September 1, 2017

Ms. Daniela Ortiz de Montellano, Project Manager
Texas Commission on Environmental Quality
Municipal Solid Waste Permit Section (MC-124)
Waste Permits Division
12100 Park 35 Circle, Bldg. F
Austin, Texas 78753

Re: Response to Technical Notice of Deficiency Email, Tracking No. 21762642
Downstream Environmental, LLC - B.R. Perrin Plant - Harris County Texas
Municipal Solid Waste (MSW) Permit No. 2298
Permit Modification - Alternative Buffer Zone
CN600896872 / RN101662617

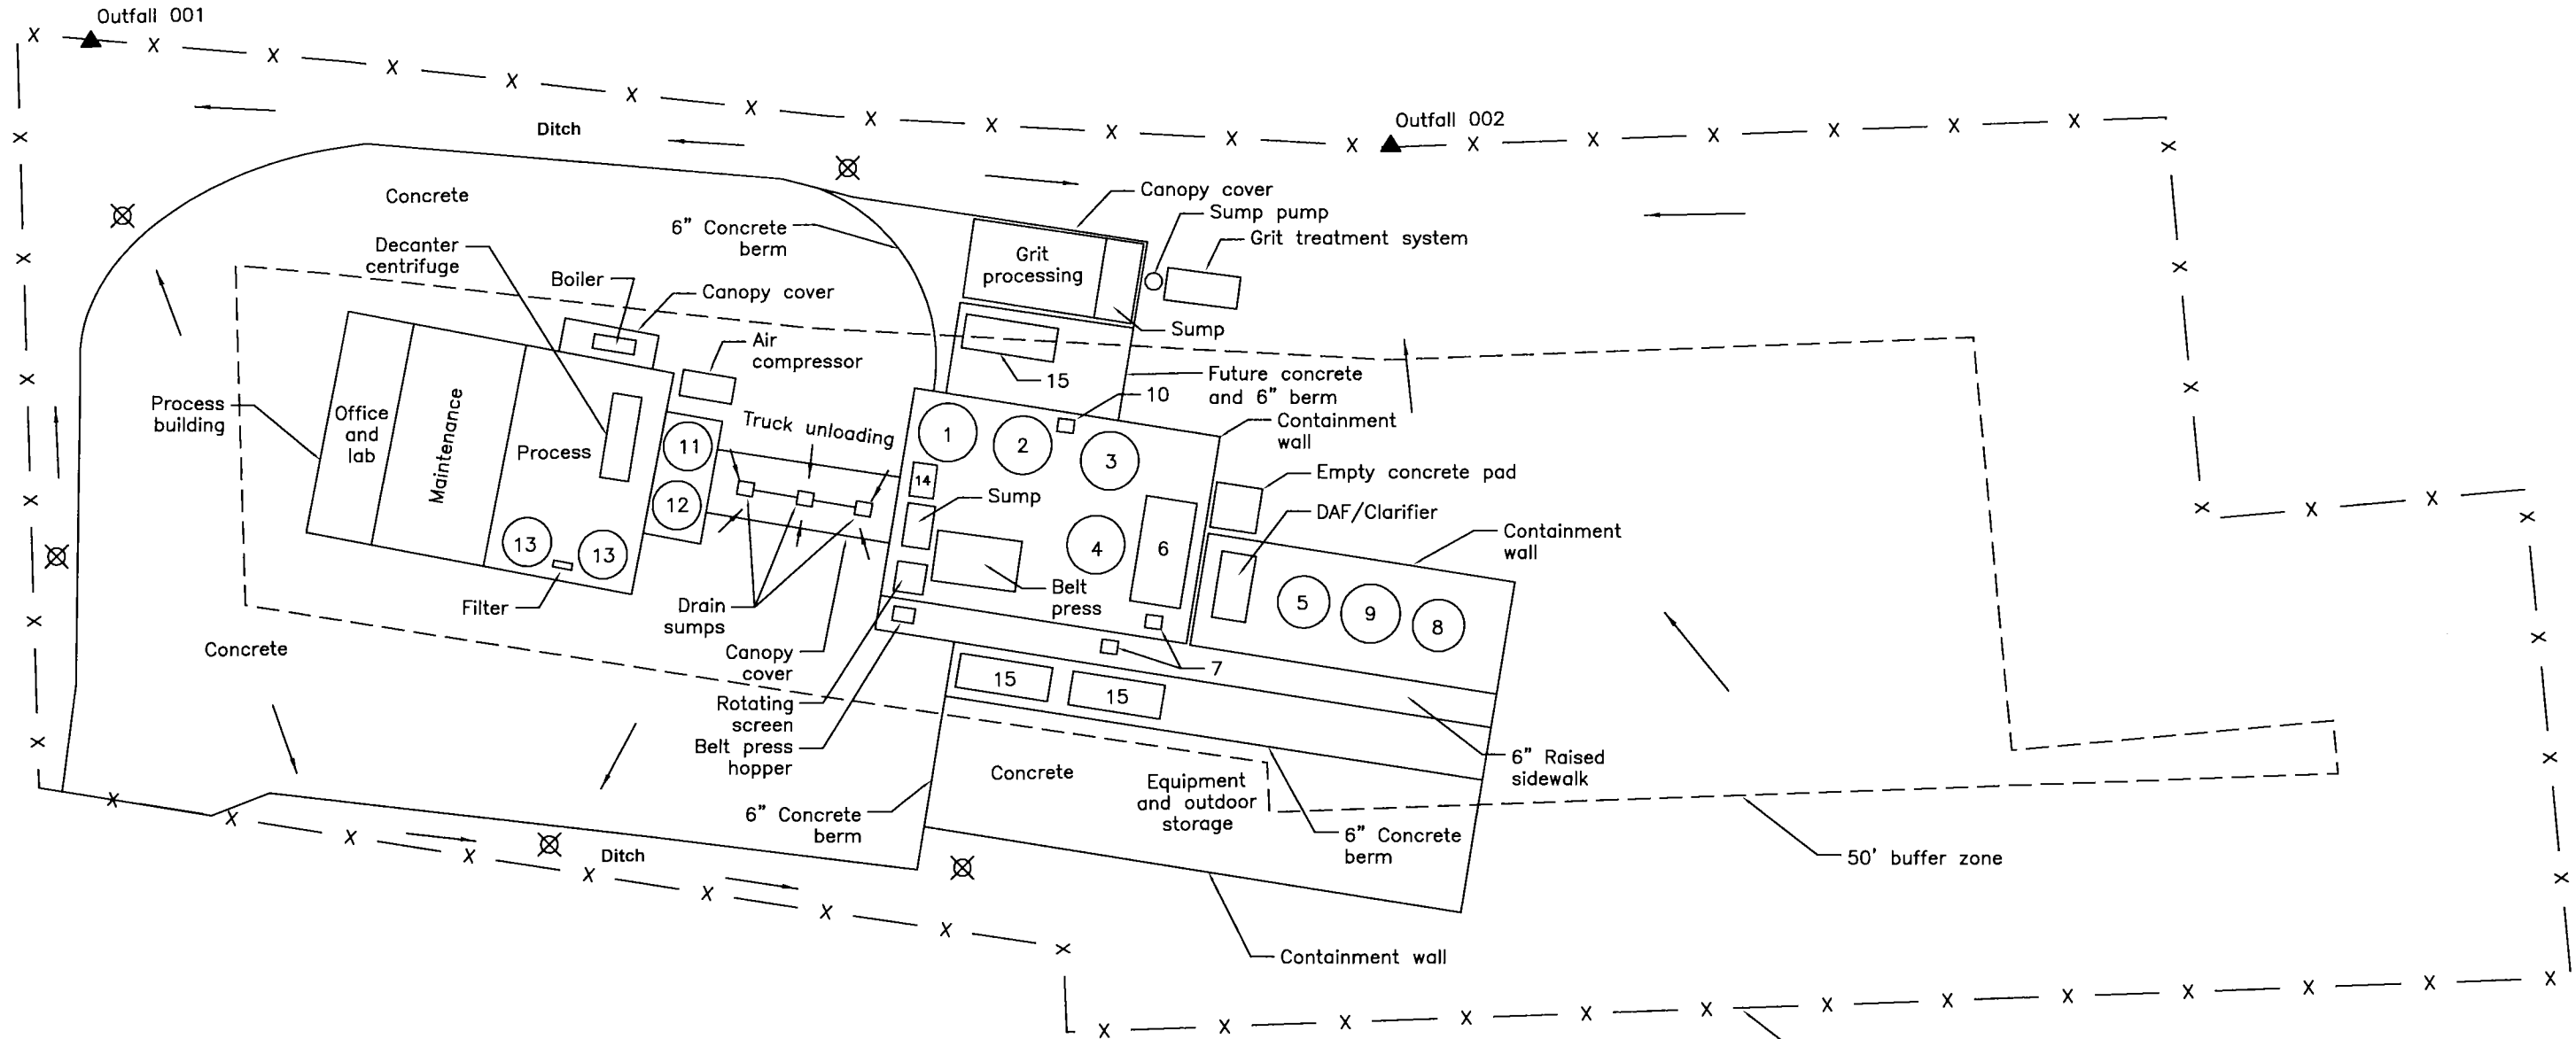
***TCEQ Item 2:** Part II, Variance #1: Location of Grit Processing Area, page 15; please explain how the proposed alternative buffer zone of 26 feet will afford ready access for emergency vehicles and maintenance in accordance with 30 TAC §330.543(b).*

***TCEQ Item 5:** Part III, Facility Site Plan; please revise the Facility Site Plan to show the fence line along the south side of the facility permit boundary. In addition, clearly delineate the property /permit boundary of the facility; and delineate the buffer zone along the facility permit boundary.*

Part II, page 15, has been revised to include the following text: "A minimum 12-foot access lane for emergency vehicles will be provided and will be located between the grit processing area and the containment wall immediately to the west." This area is indicated on the Facility Site Plan drawing as 'Future concrete and 6" berm'.

The Facility Site Plan has been revised to show the entire fence line / permit boundary. A line delineating the 50-foot buffer zone has also been added the figure.
